1 Q. Reference: Labrador Expansion Study, p. 34 (p. 42 pdf)

Figure 6: Projected Rate Increase vs. Capital Investment

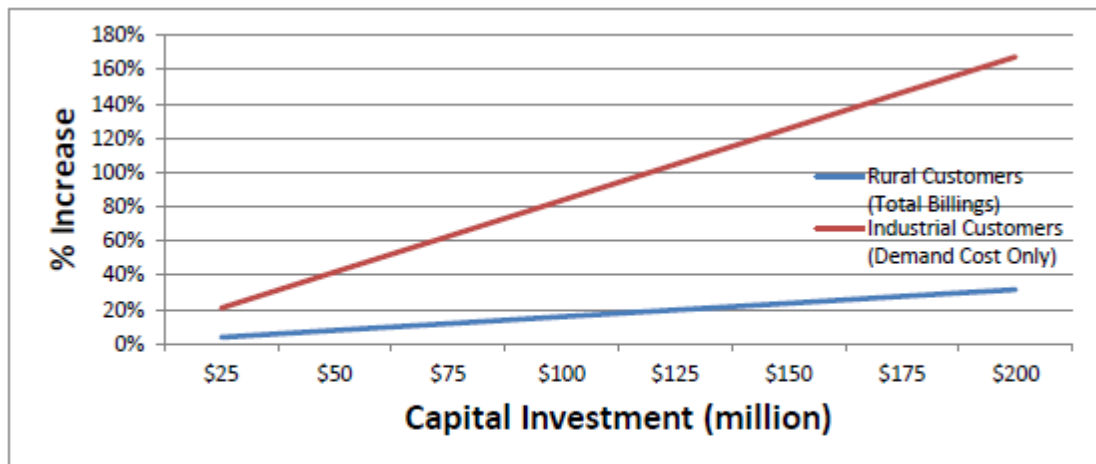
19 Figure 6 suggests a linear relationship between capital investment and rate increases.

20 However, given that the transmission expansion projects selected in the study are large and
21 “lumpy”, the relationship between load increases and rate impacts does not follow a
22 straight line.

1 Please present block graphs, separately for Labrador East and Labrador West, that indicate:

3 a) On the x-axis, peak load,

5 b) On the left y-axis, capital expenditures for transmission infrastructure required to meet
6 the peak load on the x-axis, and

8 c) On the right y-axis, the % rate increase for rural customers resulting from those
9 investments.

12 A. The information requested would differ depending on which project in the “Labrador
13 Interconnected System Transmission Expansion Study” was selected. It is also entirely
14 dependant on particular customer demands. Figure 6 was provided as a basis for the
15 generic calculation of forecast rate impacts for rural and industrial customers in Labrador.
16 As stated in the “Labrador Interconnected System Transmission Expansion Study” and
17 included in the Citation of the question above, the rate calculations requested require
18 detailed System Impact Studies in order to be performed. Newfoundland and Labrador
19 Hydro is unable to provide the graphs requested.
